World Forum for Harmonization of Vehicle Regulations**Working Party on Passive Safety****Fifty-fourth session**

**Regulation No. 127 (Pedestrian safety) - Proposal for the 01 series
of amendments to Regulation No. 127****Proposal of 01 series of amendments to Regulation No. 127****Submitted by the experts from the informal working group
on global technical regulation No. 9 Phase 2***

The text reproduced below was prepared by the experts from the informal working group on global technical regulation No. 9 Phase 2 (GTR9-PH2) proposing provisions on pedestrian protection of motor vehicles. The modifications to the text of the UN Regulation are marked in bold for new or strikethrough for deleted characters.

"Figure 1

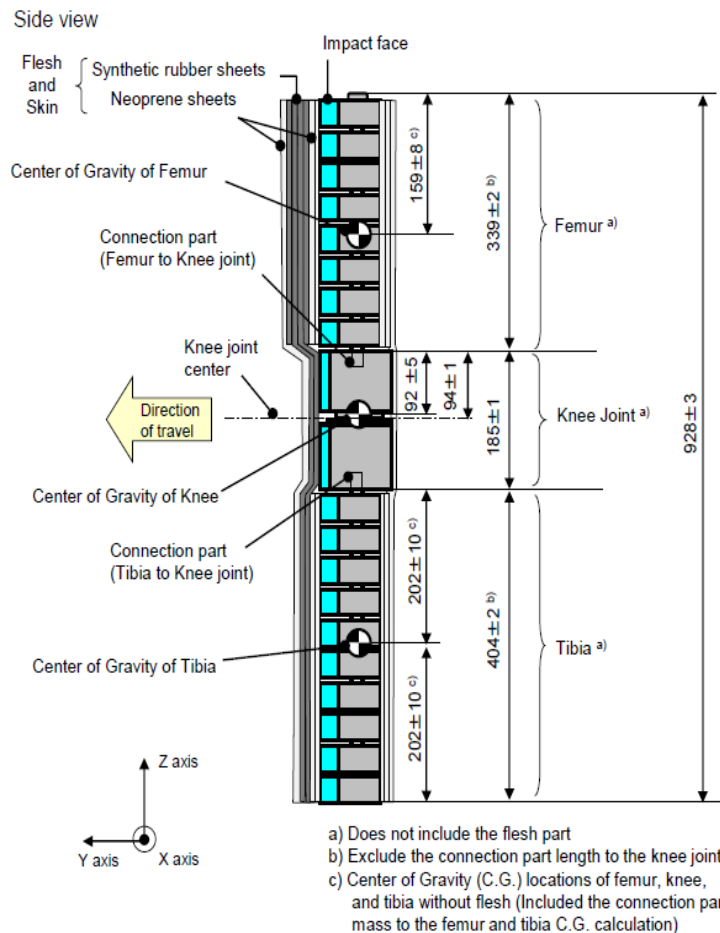
- The flexible lower legform impactor shall consist of flesh and skin, flexible long bone segments (representing femur and tibia), and a knee joint as shown in Figure 1. The assembled impactor shall have a total mass of $13.2 \pm [0.7]$ kg. The dimensions of the fully assembled impactor shall be as defined in Figure 1.**

The centres of gravity of the femur and tibia without the flesh and skin, including the connection parts to the knee joint, shall be as defined in Figure 1. The centre of gravity of the knee joint shall be as defined in Figure 1.

Figure 2
Flexible lower legform impactor schematic plan views of femur, tibia, and knee dimensions (top view)

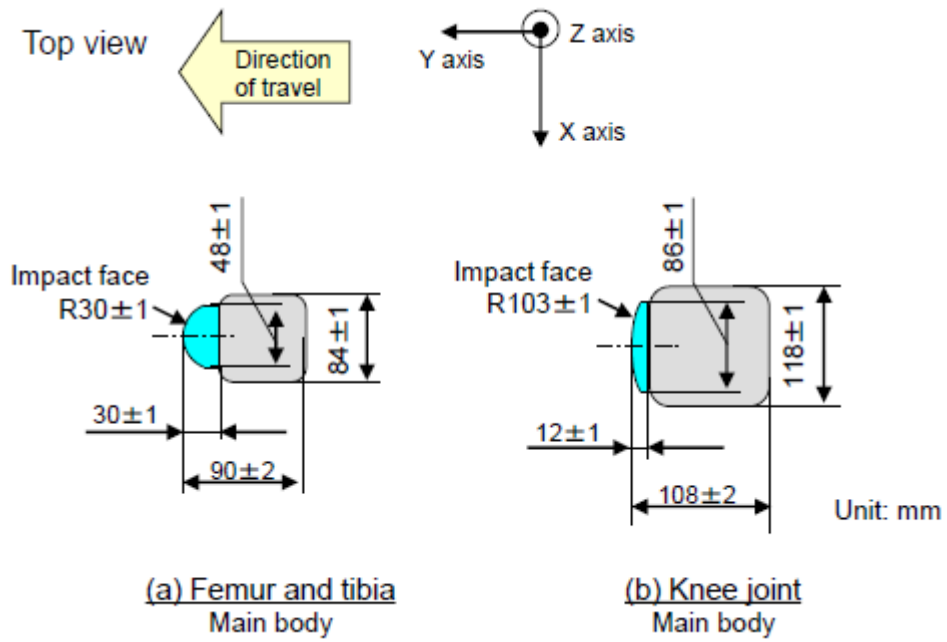
with 0.5 mm thick nylon cloth on both sides, with an overall thickness of 6 mm. The cross-sectional shape of the femur main body segments, the tibia main body segments and their impact faces shall be as defined in Figure 2(a).

- 1.3. ~~The knee joint shall be fitted with deformable knee elements from the same batch as those used in the certification tests.~~ **The cross-sectional shape of the knee joint and its impact face shall be as defined in Figure 2 (b).**

Figure 3
Flexible lower legform impactor instrument locations

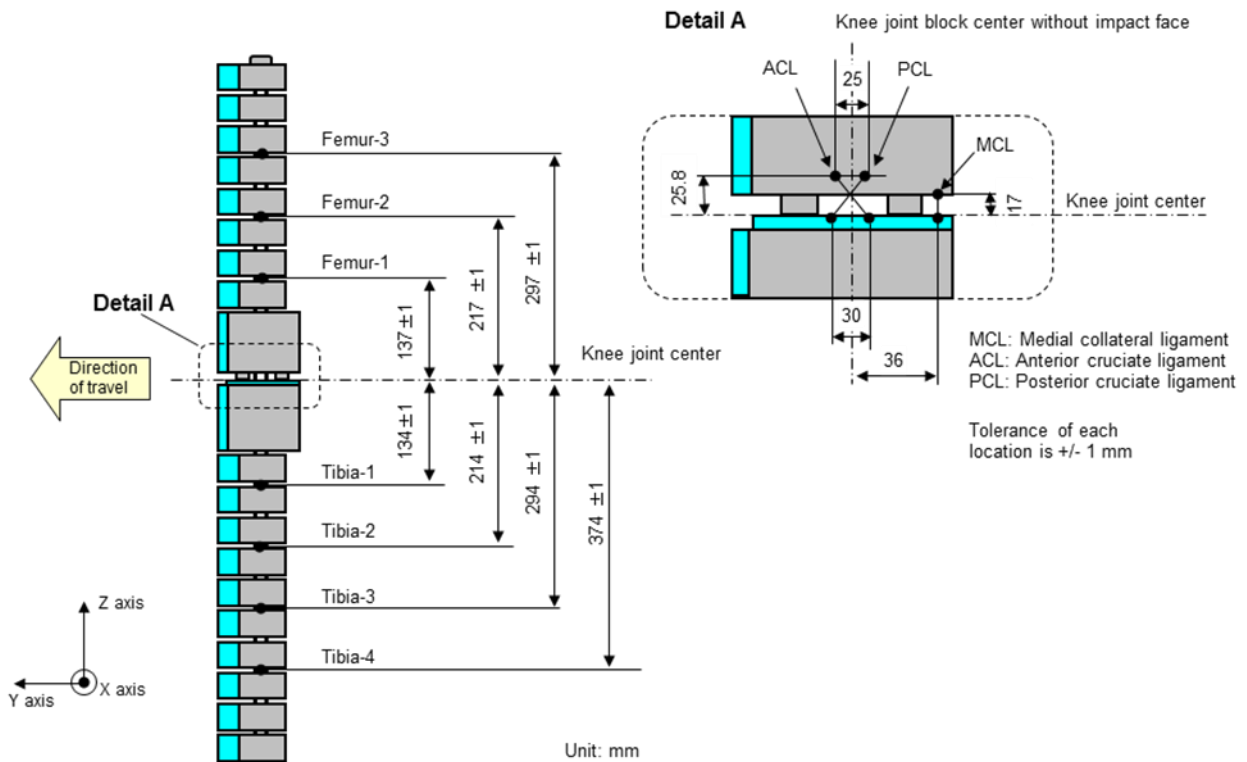
- "2.1. ~~An uniaxial accelerometer shall be mounted on the non impacted side of the tibia, 66 ± 5 mm below the knee joint centre, with its sensitive axis in the direction of impact.~~ **Four transducers shall be installed in the tibia to measure bending moments at the locations within the tibia. Three transducers shall be installed in the femur to measure bending moments applied to the femur. The sensing locations of each of the transducers are as defined in Figure 2. The measurement axis of each transducer shall be the X-axis of the impactor.**

- 2.2. ~~A damper shall be fitted to the shear displacement system and may be mounted at any point on the rear face of the impactor or internally. The damper properties shall be such that the impactor meets both the static and dynamic shear displacement requirements and prevents excessive vibrations of the shear displacement system.~~ **Three transducers shall be installed in the knee joint to measure elongations of the medial collateral ligament (MCL), anterior cruciate ligament (ACL), and posterior cruciate ligament (PCL). The measurement locations of each transducer are shown in Figure 3. The measurement locations shall be within ± 4 mm along the X-axis from the knee joint centre.**

"Figure 1
Flexible lower legform impactor: Flesh and skin dimensions

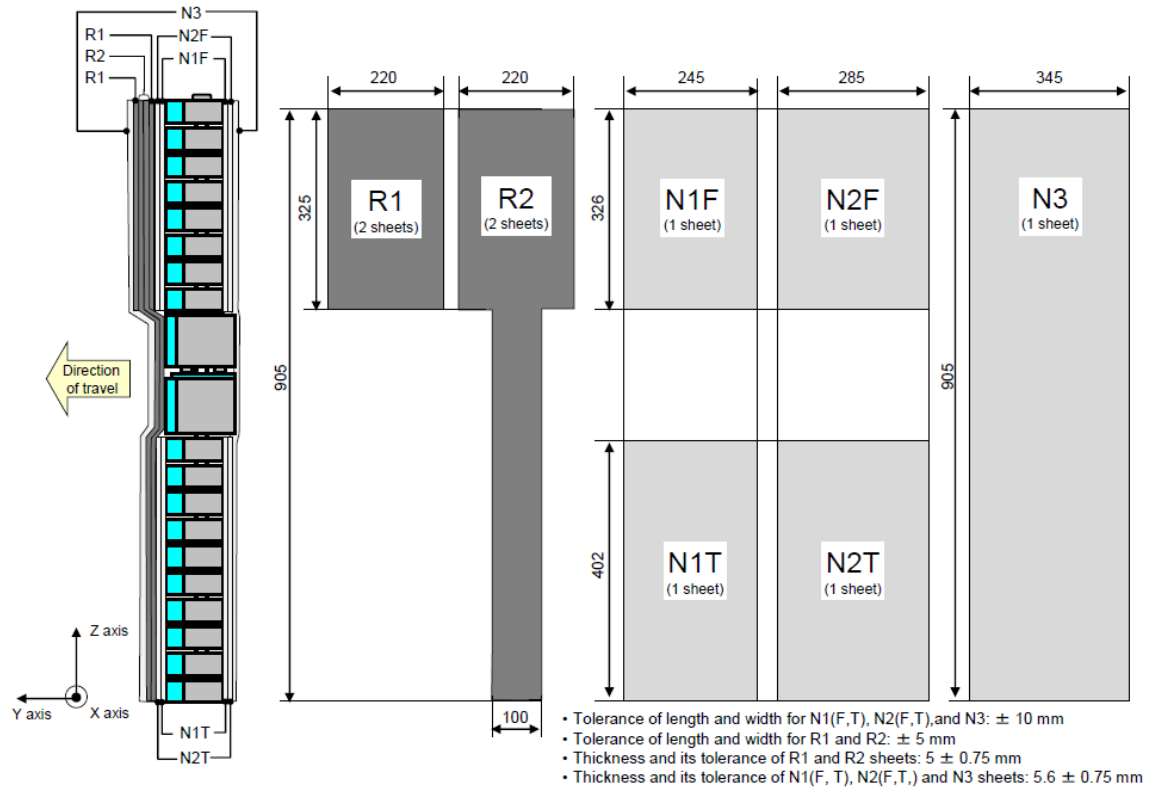
1.1. For each test the impactor ~~shall be fitted with new foam flesh cut from one of up to four consecutive sheets of foam type CF 45 flesh material or equivalent, produced from the same batch of manufacture (cut from one block or "bun" of foam), provided that foam from one of these sheets was used in the dynamic certification test and the individual weights of these sheets are within ± 2 per cent of the weight of the sheet used in the certification test.~~ **(femur, knee joint and tibia) shall be covered by flesh and skin composed of synthetic rubber sheets (R1, R2) and neoprene sheets (N1F, N2F, N1T, N2T, N3) as shown in Figure 1. The size of the sheets shall be within the requirements described in Figure 1. The sheets are required to have compression characteristics as shown in Figure 2. The compression characteristics shall be checked using material from the same batch as the sheets used for the impactor flesh and skin.**

Figure 2
Flexible lower legform impactor: Flesh and skin compression characteristics

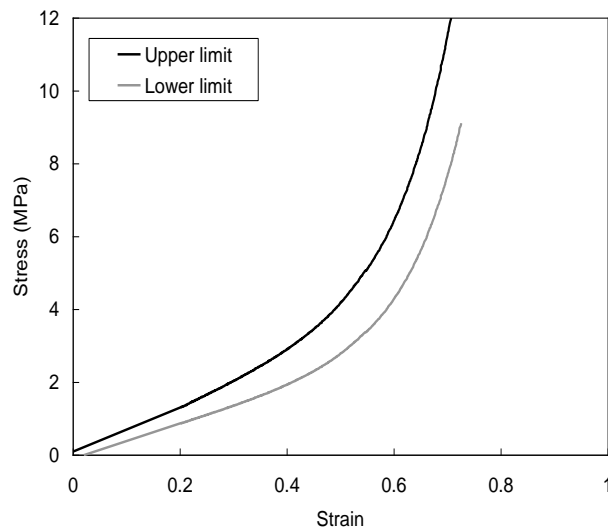
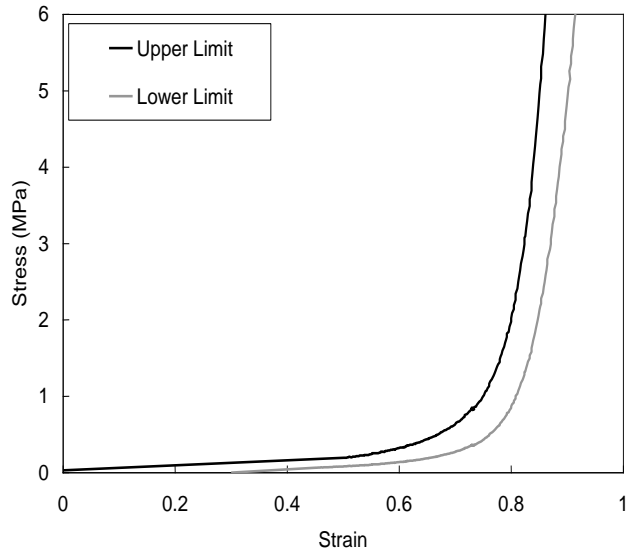
removed. The neoprene sheet used in this test shall have compression characteristics as shown in Figure 2 (b) of Annex 5.

Tolerances of angles for the **flexible** lower legform impactor at the time of the first impact

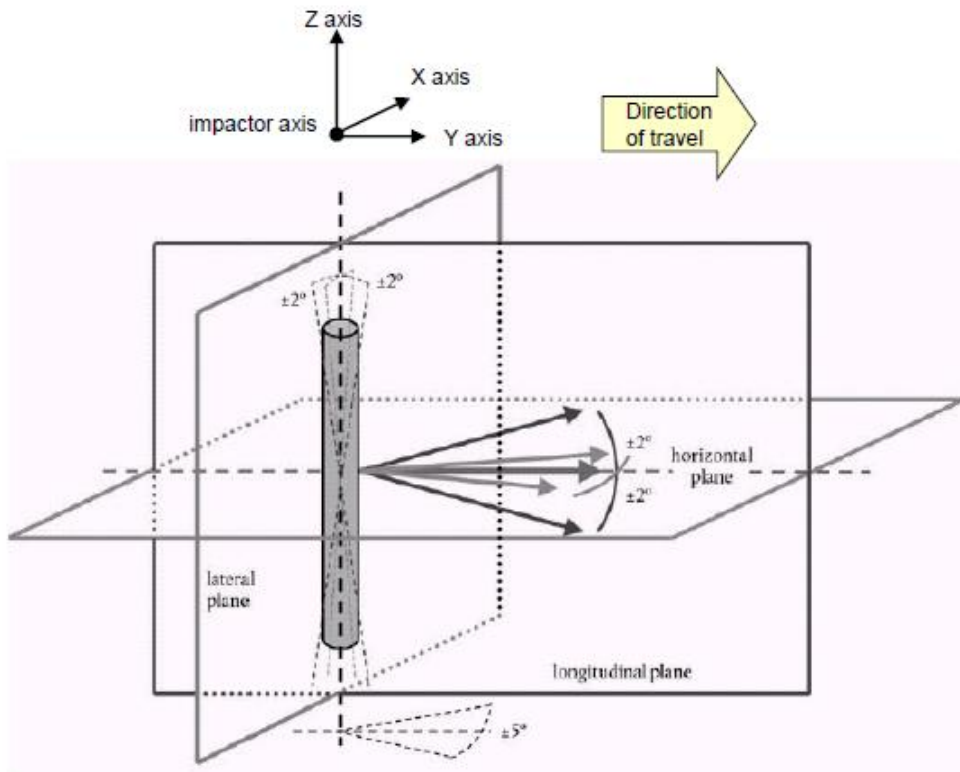
"1.6. The direction of the impact velocity vector shall be in the horizontal plane and parallel to the longitudinal vertical plane of the vehicle. The tolerance for the direction of the velocity vector in the horizontal plane and in the longitudinal plane shall be $\pm 2^\circ$ at the time of first contact. The axis of the impactor shall be perpendicular to the horizontal plane with a **roll and pitch angle** tolerance of $\pm 2^\circ$ in the lateral and longitudinal plane. The horizontal, longitudinal and lateral planes are orthogonal to each other (see Figure 43).

- 1.9. At the time of first contact the impactor shall have the intended orientation about its vertical axis, for the correct operation of its knee joint, with a **yaw angle** tolerance of $\pm 5^\circ$ (see Figure 43)."

Flexible lower legform **impactor** to bumper tests for complete vehicle in normal ride attitude (left) and for cut-body mounted on supports (right)

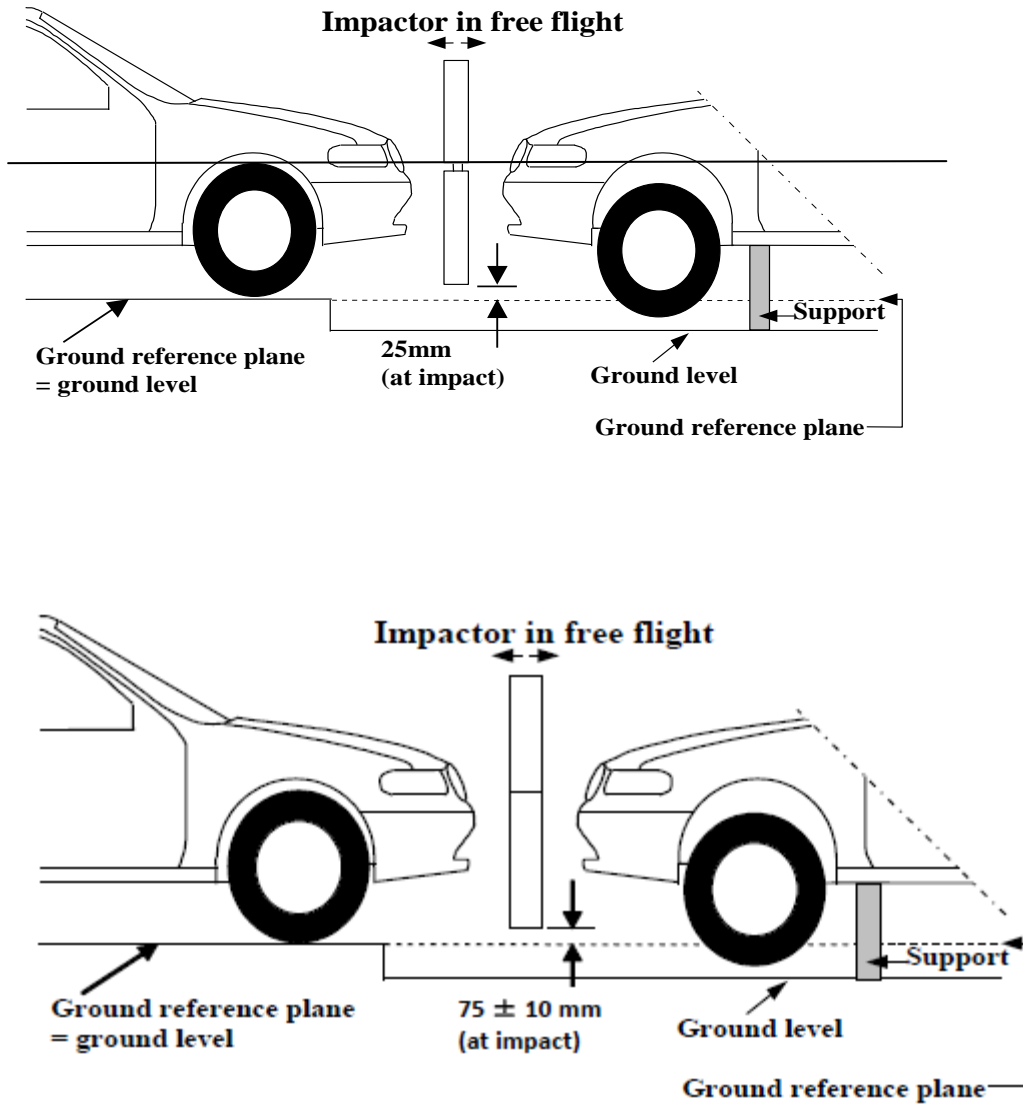
1.7. The bottom of the impactor **(without parts needed for the purposes of launching and/or protection)** shall be at ~~25~~ **75** mm above ground reference plane at the time of first contact with the bumper (see Figure 24), with a ± 10 mm tolerance. When setting the height of the propulsion system, an allowance must be made for the influence of gravity during the period of free flight of the impactor.

Flexible lower legform impactor: Requirement corridors of the femur and the tibia in the static certification test (see paragraph 1.2.2. of this Annex)

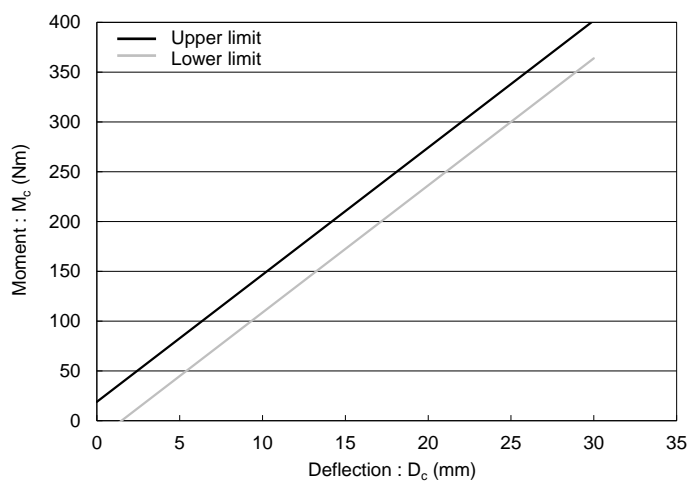
- 1.2.2. **When the femur and the tibia of the impactor are loaded in bending in accordance with paragraph 1.2.4., the applied moment and the generated deflection at the centre of the femur and the tibia (M_c and D_c) shall be within the corridors shown in Figure 1.**

Figure 2
Flexible lower legform impactor: Requirement corridors for the knee joint in the static certification test (see paragraph 1.2.3. of this Annex)

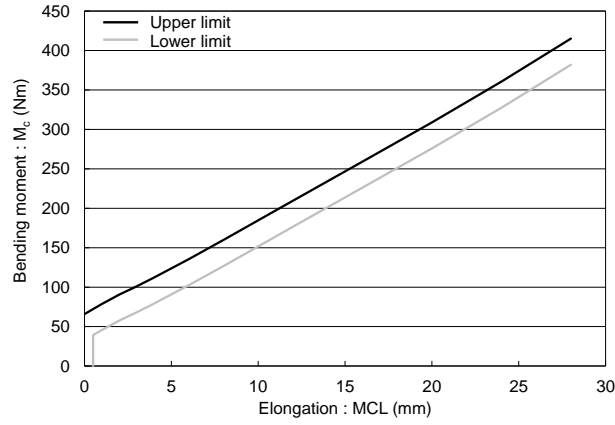
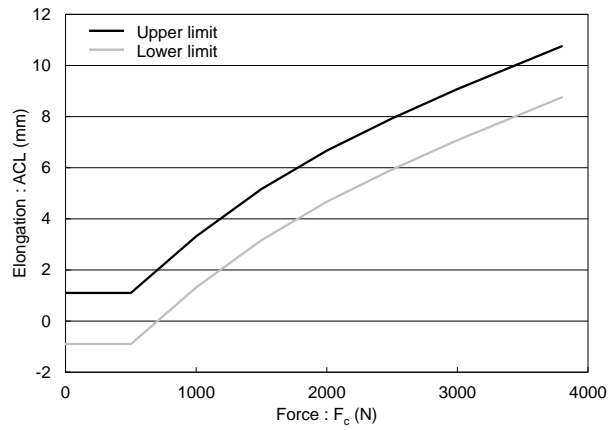
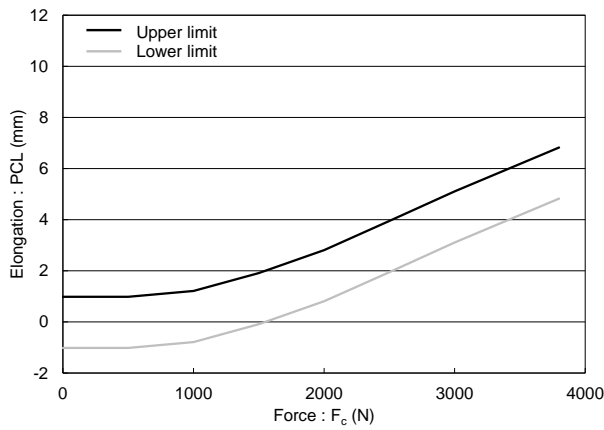
- 1.2.3. **When the knee joint of the impactor is loaded in bending in accordance with paragraph 1.2.5 of this Annex, the MCL, ACL, and PCL elongations and applied bending moment or the force at the centre of the knee joint (M_c or F_c) shall be within the corridors shown in Figure 2.**

Figure 3
Flexible lower legform: Impactor test set-up for the femur in the static certification test (see paragraph 1.2.4. of this Annex)

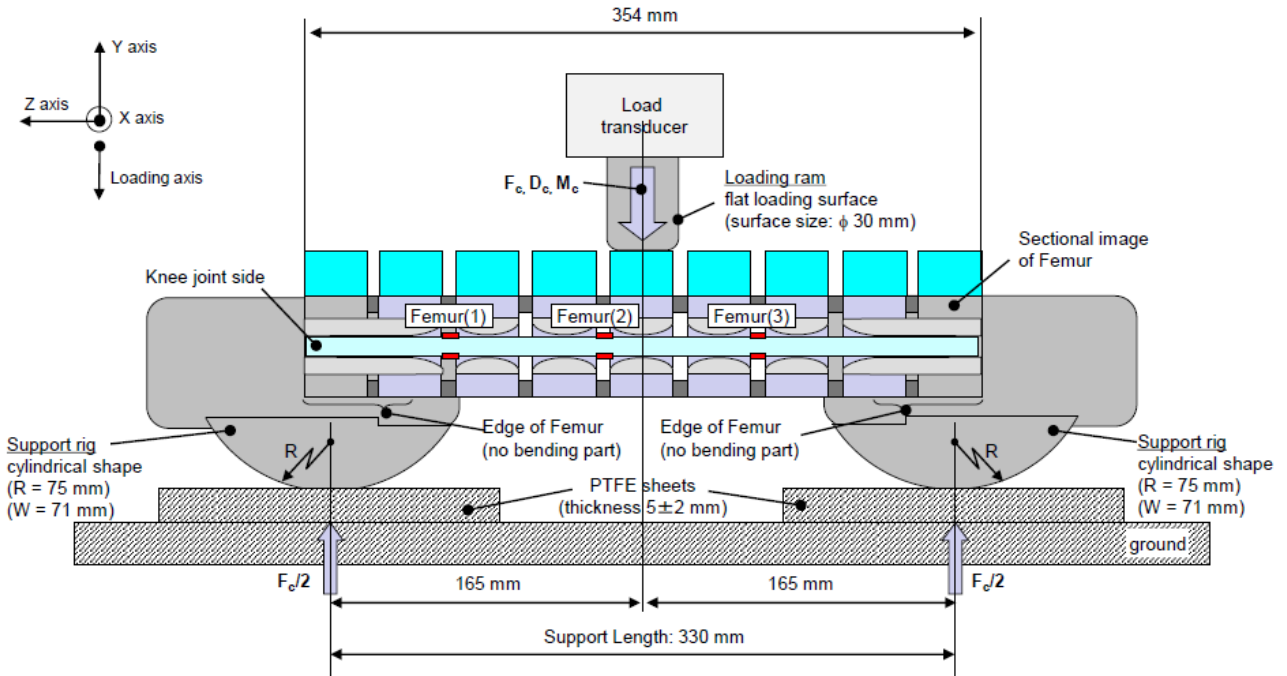
- 1.2.4. **The edges of the femur and tibia, not bending parts, shall be mounted to the support rig firmly as shown in Figure 3 and Figure 4. The Y-axis of the impactor shall be parallel to the loading axis within $180 \pm 2^\circ$ tolerance. To obtain repeatable loading, low friction Polytetrafluoroethylene (PTFE) plastic pads are used under each support (see Figure 3 and Figure 4).**

The centre of the loading force shall be applied at the centre of the femur and the tibia within ± 2 mm tolerance along the Z-axis. The force shall be increased so as to maintain a deflection rate between 10 and 100 mm/minute until the bending moment at the centre part (M_c) of the femur or tibia reaches 380 Nm.

Figure 5
Flexible lower legform impactor: Test set-up for the knee joint in the static certification test (see paragraph 1.2.5.)

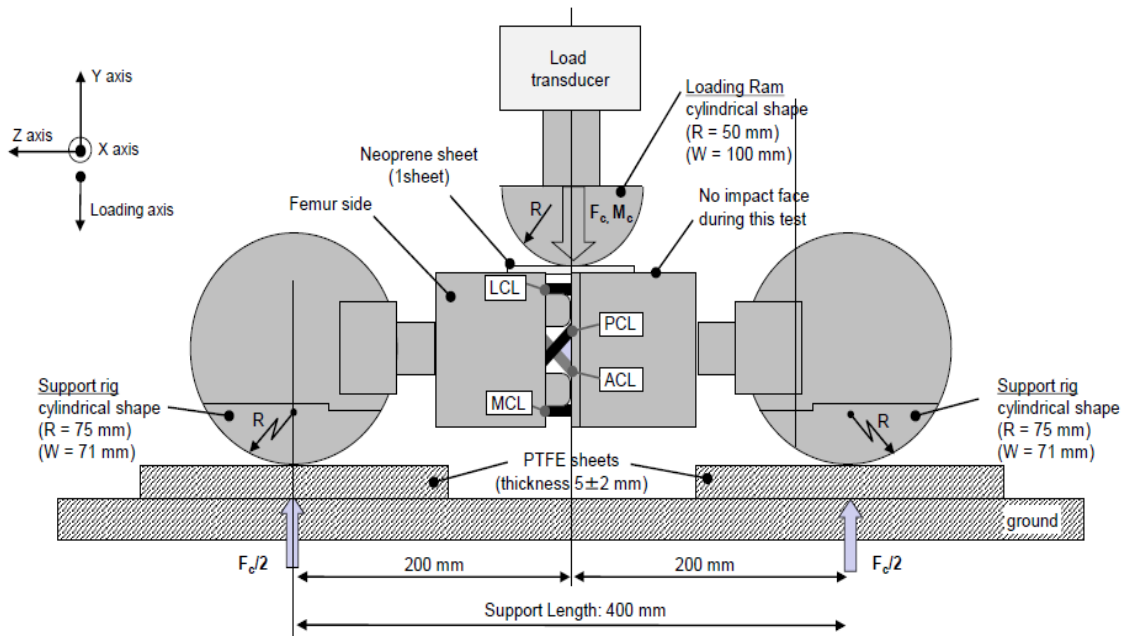
- 1.2.5. **The ends of the knee joint shall be mounted to the support rig firmly as shown in Figure 5. The Y-axis of the impactor shall be parallel to the loading axis within $\pm 2^\circ$ tolerance. To obtain repeatable loading, low friction Polytetrafluoroethylene (PTFE) plastic pads are used under each support (see Figure 5). To avoid impactor damage, a neoprene sheet shall be set underneath the loading ram and the impactor face of the knee joint which is described in the Figure 3 (b) of Annex 4 shall be**

The centre of the loading force shall be applied at the knee joint center within ± 2 mm tolerance along the Z-axis (see Figure 5). The external load shall be increased so as to maintain a deflection rate between 10 and 100 mm/minute until the bending moment at the centre part of the knee joint (M_c) reaches 400 Nm.

Figure 6
Flexible lower legform impactor: Test set-up for the dynamic lower legform impactor certification test (pendulum test, see paragraph 1.3.3.1.)

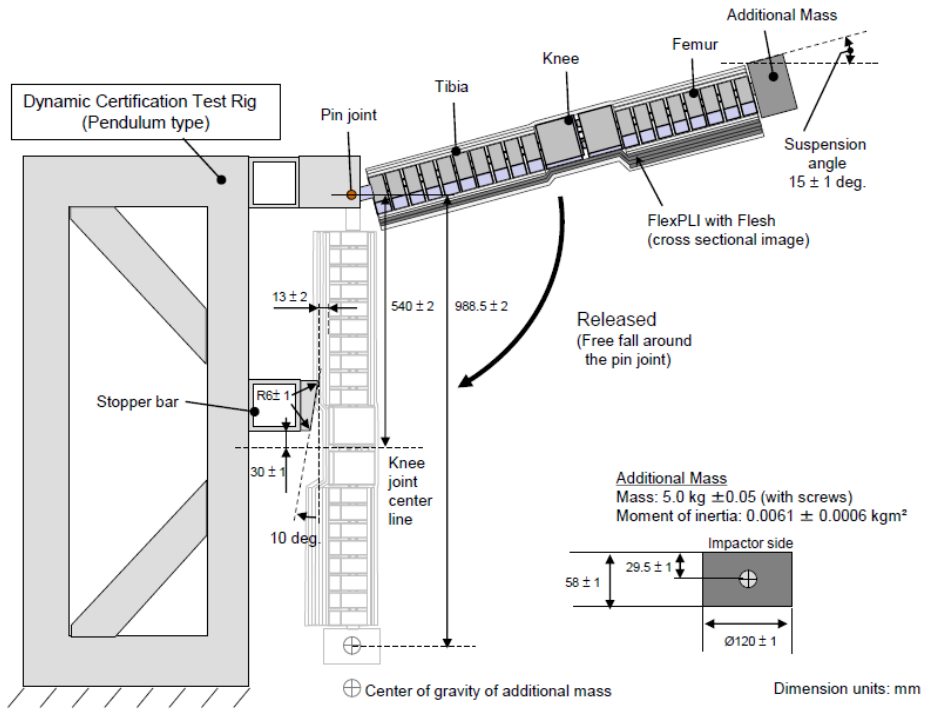
- 1.3.3.1. **The flexible lower legform impactor, including the flesh and skin, shall be suspended from the dynamic certification test rig $15 \pm 1^\circ$ upward from the horizontal as shown in Figure 6. The impactor shall be released from the suspended position and fall freely against the pin joint of the test rig as shown in Figure 6.**

- 1.3.3.2. **The knee joint centre of the impactor shall be 30 ± 1 mm below the bottom line of the stopper bar, and the tibia impact face without the flesh and skin shall be located 13 ± 2 mm from the front upper edge of the stopper bar when the impactor is hanging freely as shown in Figure 6.**
